Nine Springs, Article 3 Amendment 10 – Conditions  
June 15, 2021

Re: Nine Springs Article 3 Amendment 10 Submittal

Application: Nine Springs Article 3 Amendment 10

Application: Nine Springs Article 3 Amendment 10

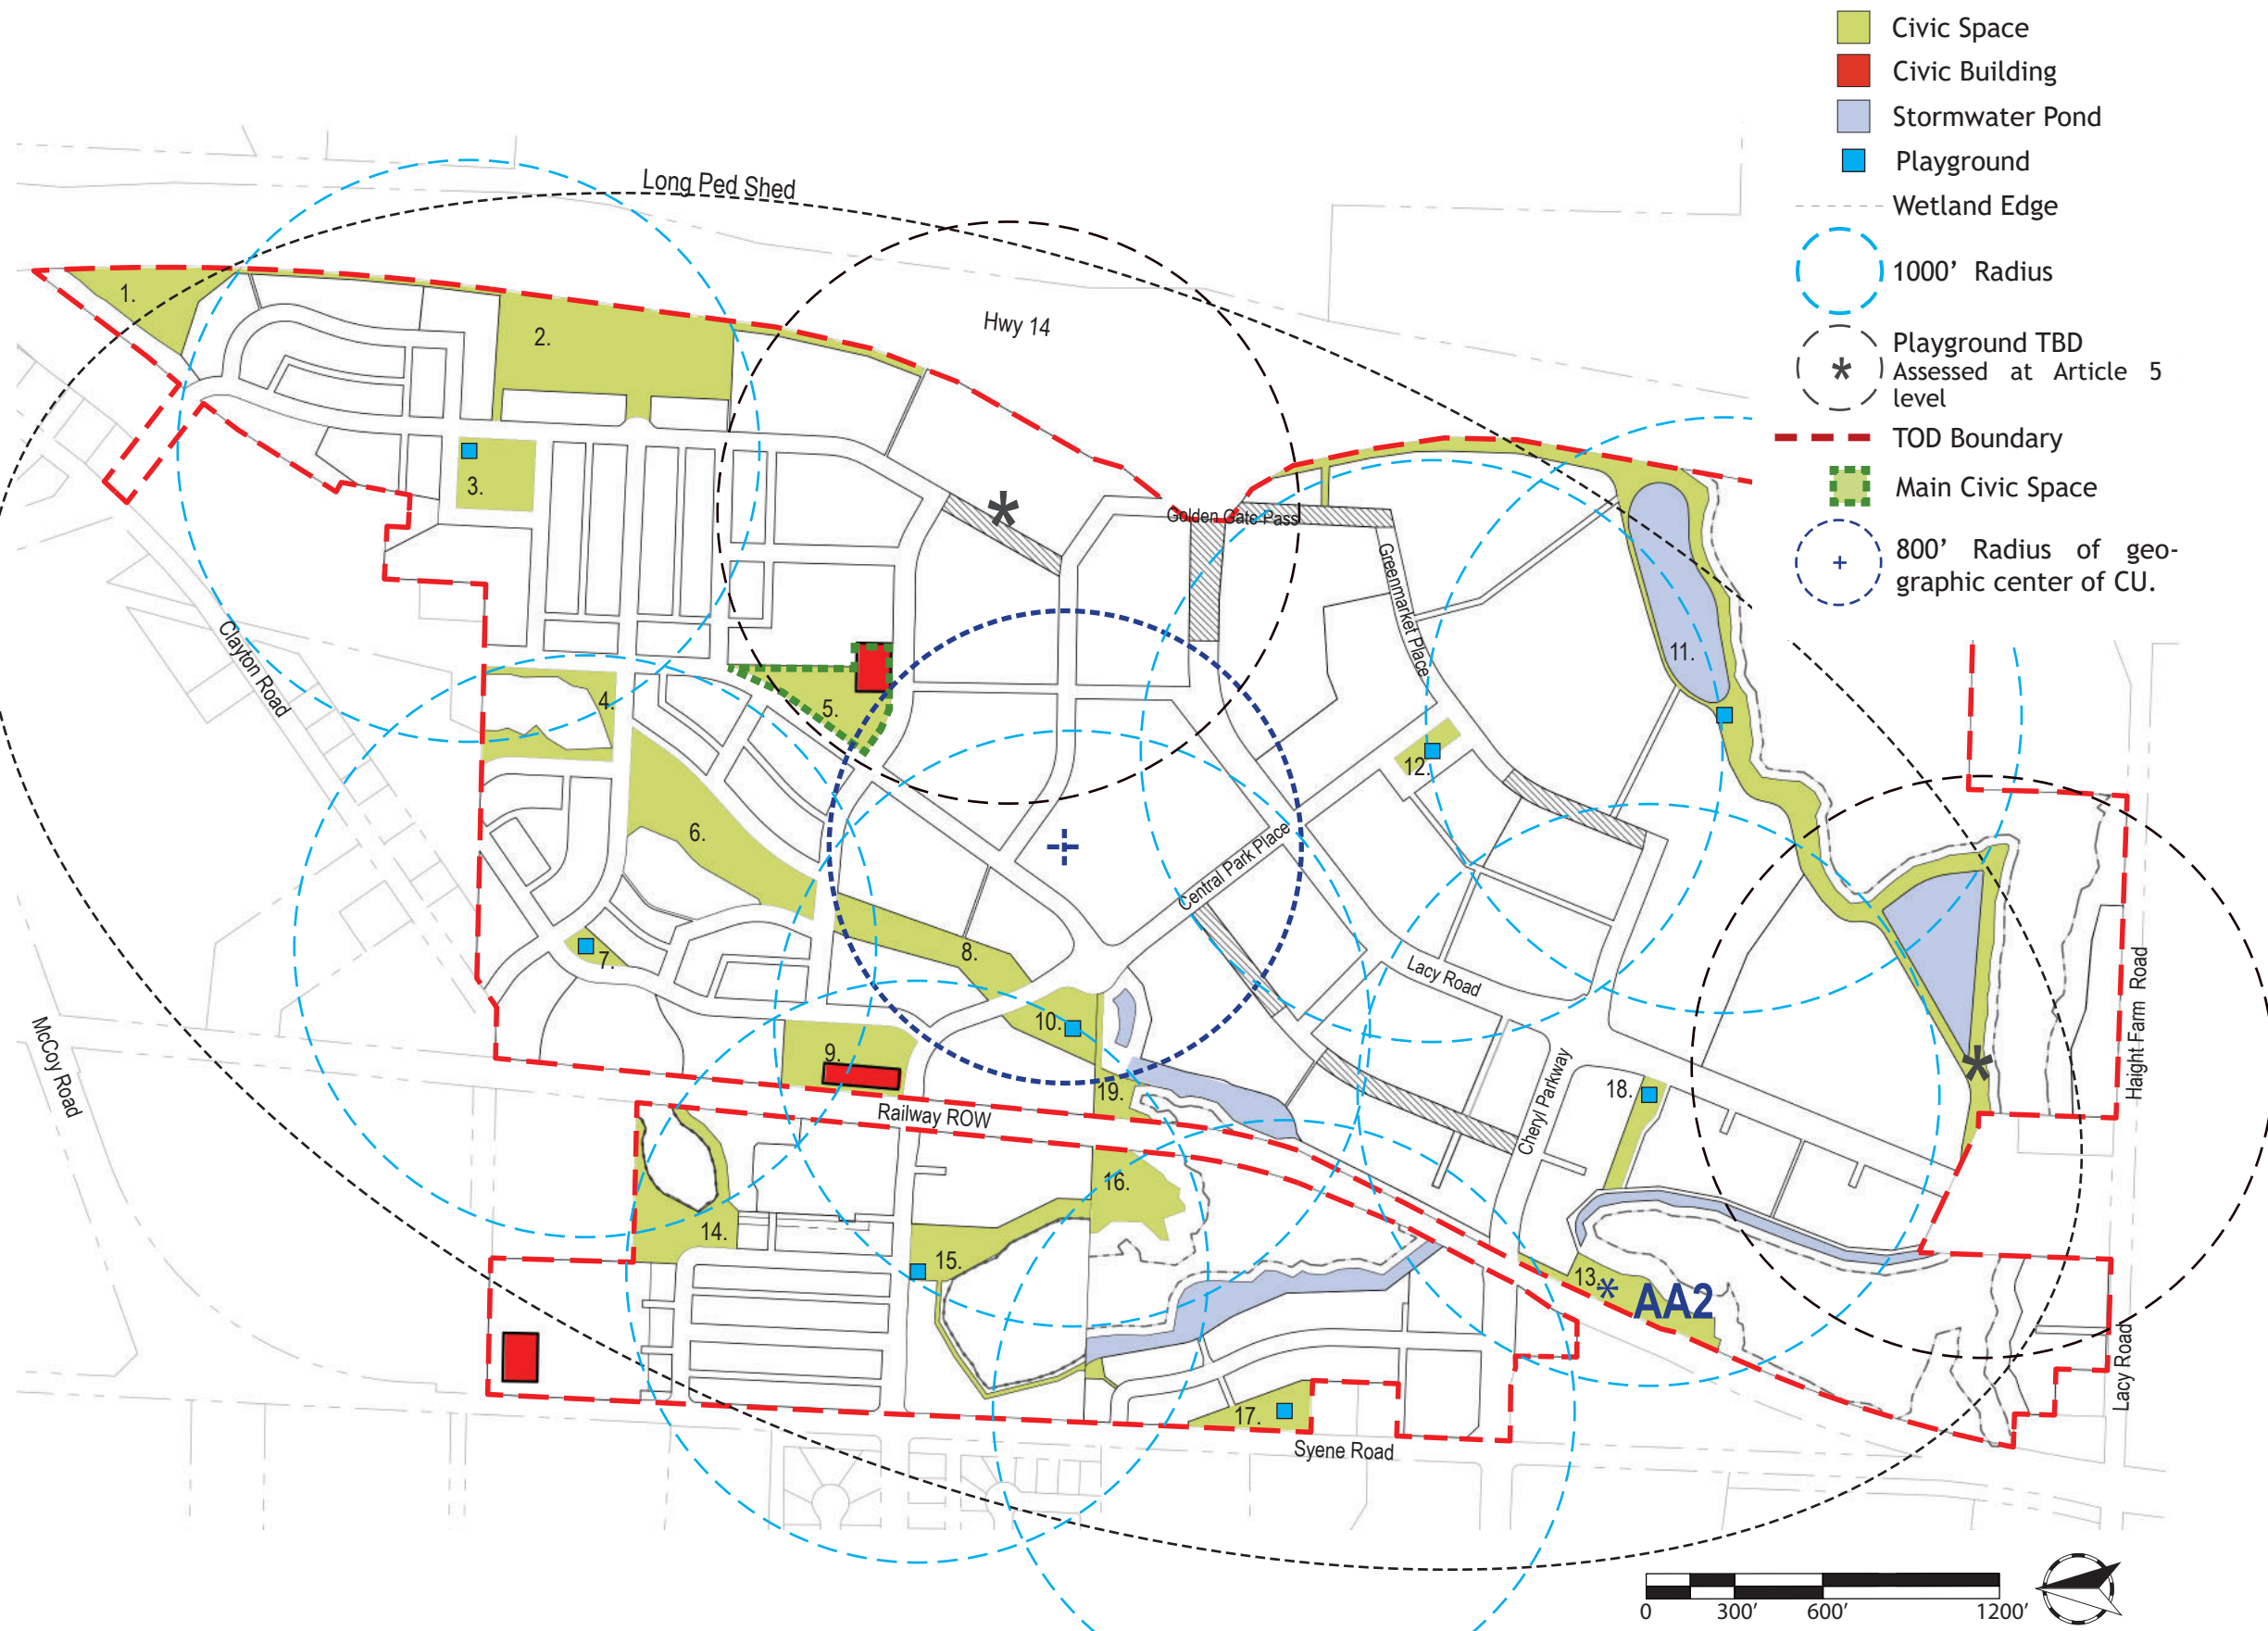
1. Why are Civic space 19 and 20 not combined? **Response: They are two different parcels.**
2. Will Civic space 20 be private or public? Is 20 ft. sufficient to provide a bike path on Civic space 20? **Response: Public. Yes 20' would be sufficient for a 10' wide bike path.**

1. Per the application Administrative Approval #11 is being requested because civic spaces 19 & 20 do not meet the 8-acre minimum for a conservancy. The code says a conservancy "should" be 8 acres. We can use the liberal interpretation of "should" and not require 8 acres. Per Table 2e. an Administrative Approval is actually required to allow conservancy space in Transect 4 or Transect 5, not to waive the acreage minimum. I understand that Administrative Approvals have been approved in the past for conservancies that are less than 8 acres. However, I believe the language was incorrectly applied.

2. Civic Space 19 & 20 should be combined to make them more conforming to the 8-acre minimum. It does not matter if they are on separate parcels. **Civic Spaces 19 & 20 have been combined into one (Civic Space 19).**

Civic spaces are controlled by the dominant adjoining Transect Zone. It appears that the dominant adjoining Transect for civic spaces 19 & 20 is Transect 1. An Administrative Approval is not required. **Request for AA #11 has been removed from application.**

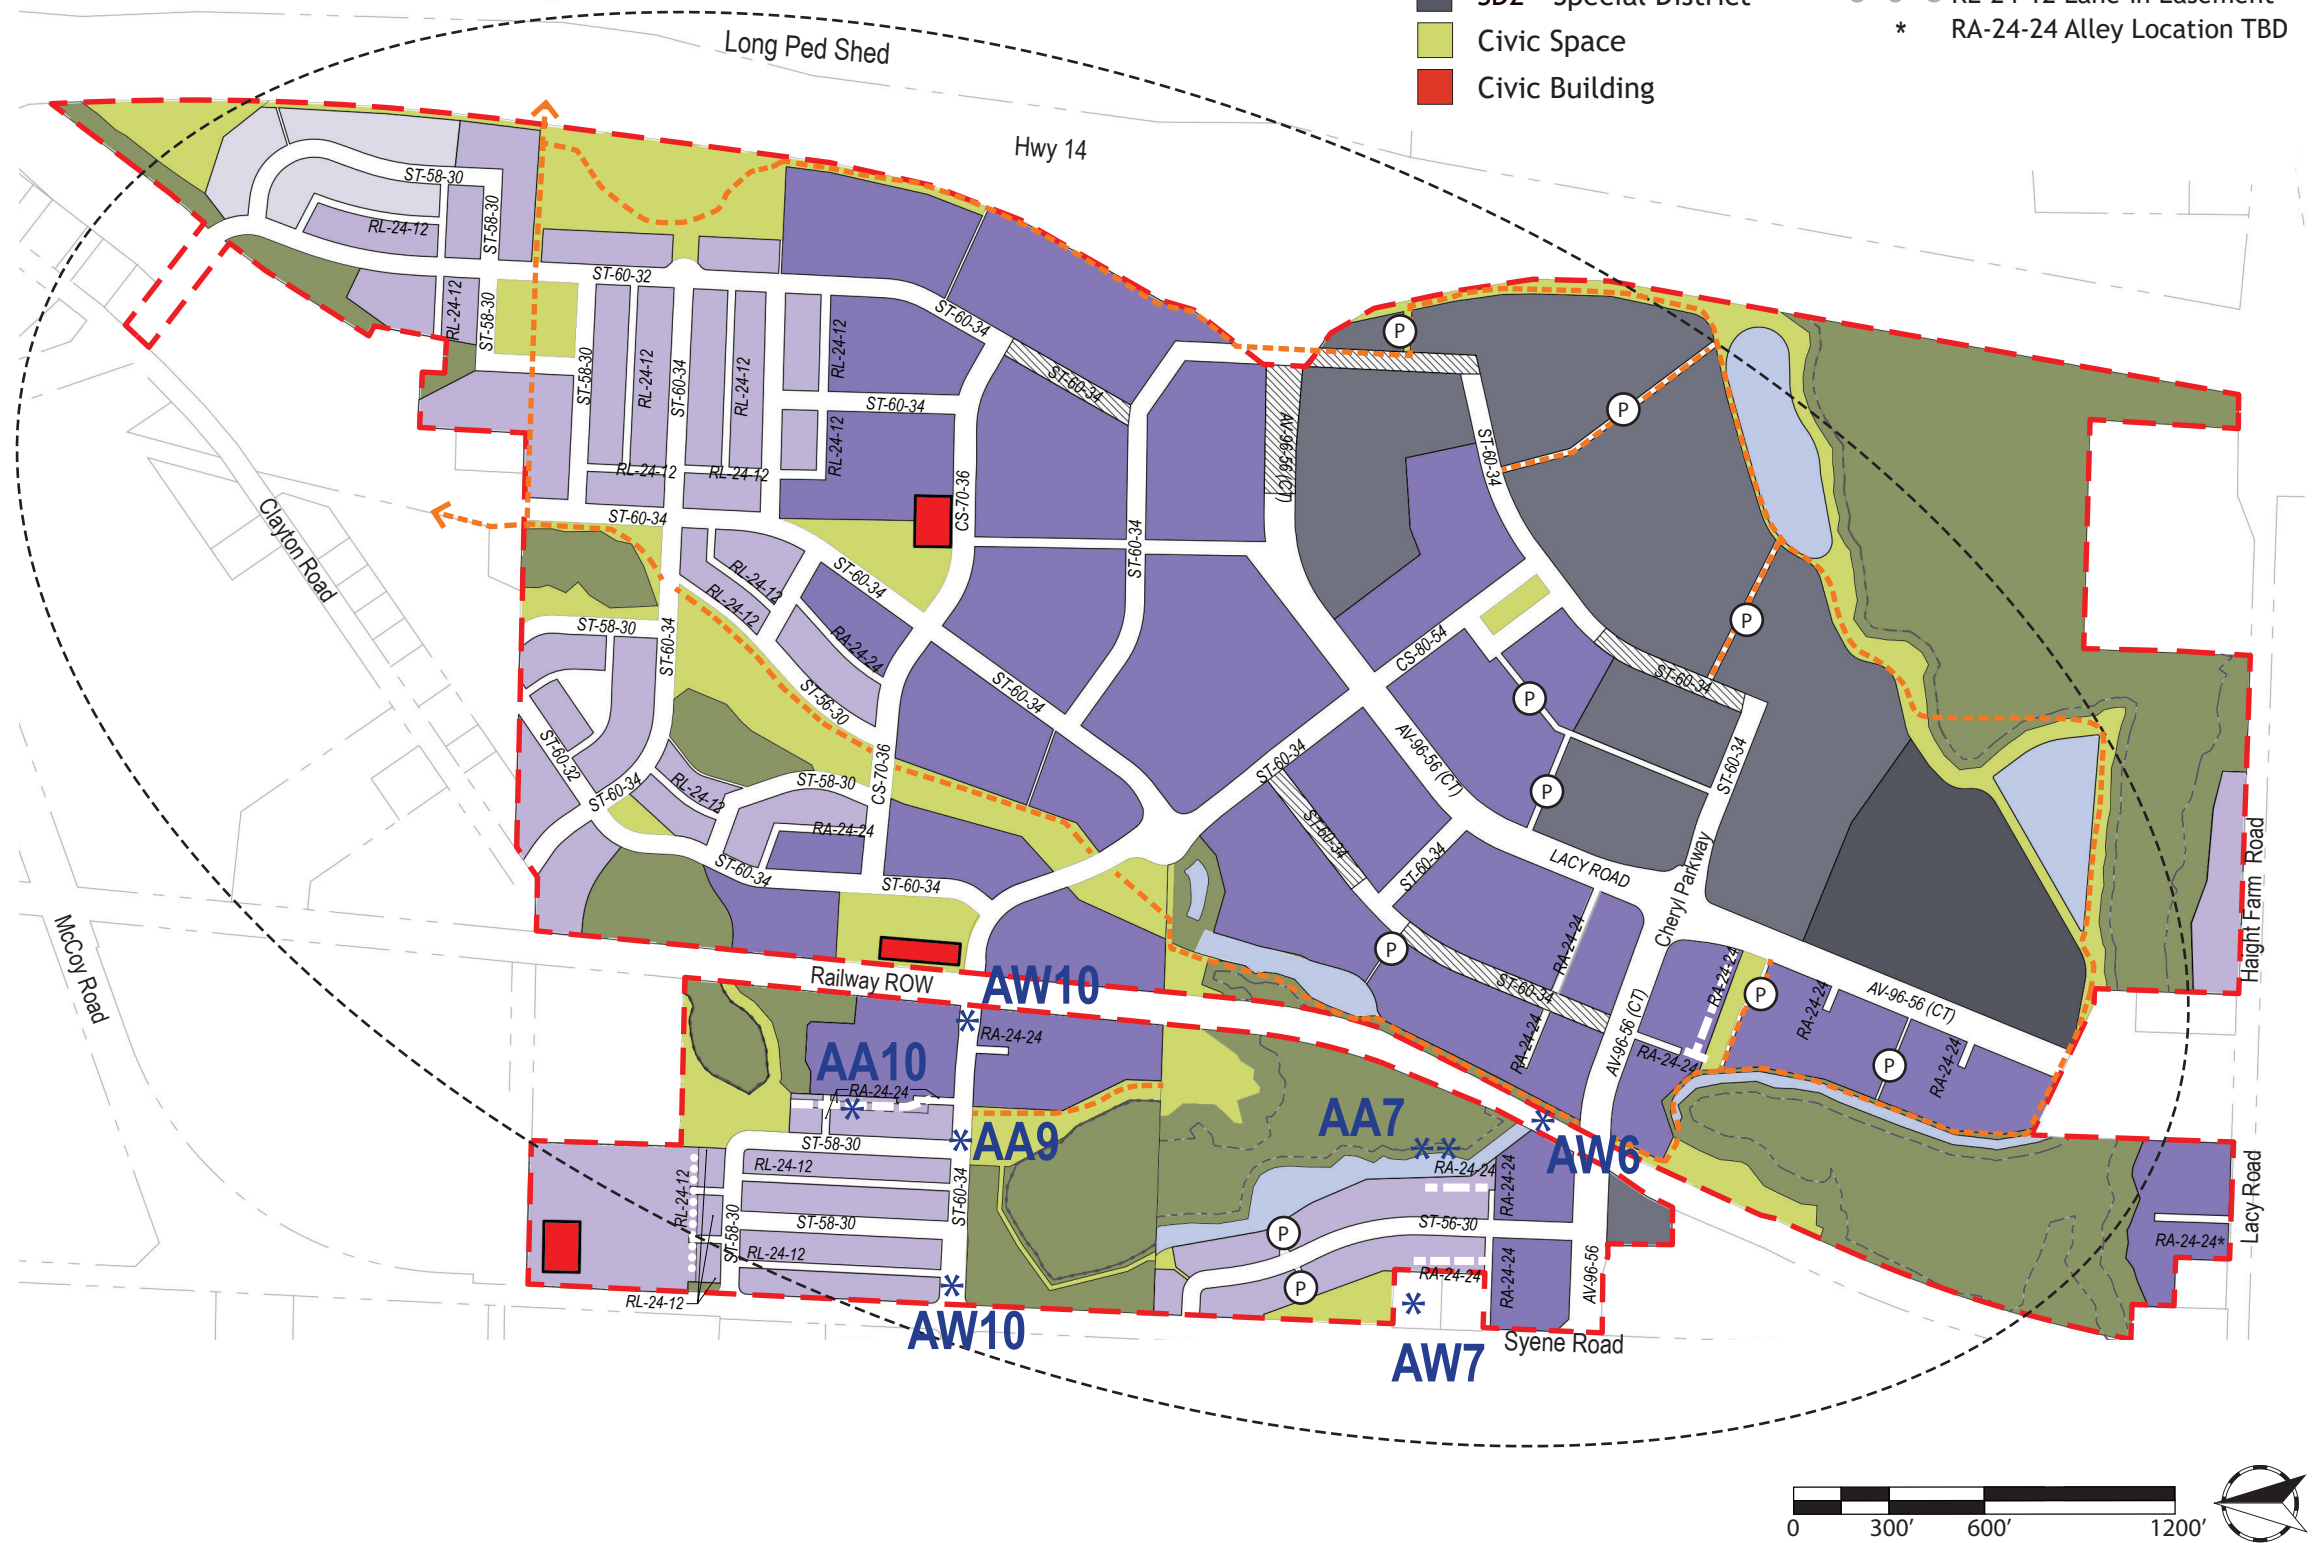
6. The rear alley on Block 31 was relocated per CSM 15609 **Response: Rear alley has been updated on Amendment 10.**
7. Has the updated Article 3 Plan been shared with other property owners? **Response: No it has not been shared.**
